**SUBJECT: Campaign #101 - Sightseer® and Sunova® Range Cabinet Partition**

## INSTRUCTIONS TO PERFORM CAMPAIGN 101 RANGE CABINET PARTITION

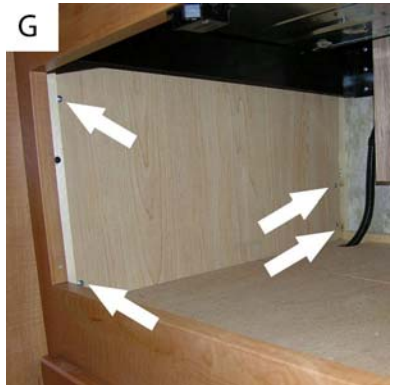
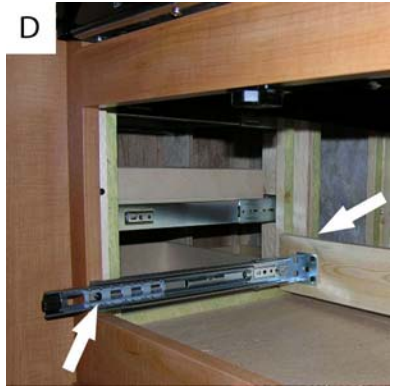
1. If you have a stovetop only model, remove the drawer beneath the stovetop. (A drawer replaces the oven in stovetop only models.) If you have a stovetop with an oven model, remove the drawers to the left of the oven.
2. Look for the panel shown in photo B (stovetop only) or photo C (stovetop with oven). If the panel is already installed, you can reinstall the drawer(s) and no further action is required. If the panel is missing, proceed to step 3.

3. If you have a stovetop only model, remove the screws attaching the drawer slides to the side of the cabinet and the screws attaching the backsocket frame to the cabinet (shown in photo D). Remove the drawer slide assembly from the cabinet.

If you have the stovetop with the oven model, you will need to remove the appliance with the following instructions.

- Turn off main propane supply at the tank.
  - Lift top of stove.
  - Remove the stove mounting fasteners (2 screws each on left and right sides- photo E) and then disconnect the gas supply line from the burner regulator (shown in photo F).
  - Lift out from cabinet and set aside.
4. Cut a panel to the size of 21 1/4" x 16 5/8" (541mm x 422mm)
  5. Install the panel to stickwork along left side of the cabinet with the #10 screws (shown in photo G). Assure that there are no gaps that will allow air exchange.
  6. If you have a stovetop only model, reinstall the drawer assembly and the drawers.  
If you have the stovetop with oven model, reinstall the oven and drawer.
  7. If the propane supply line has been disconnected, perform a propane gas leak test.
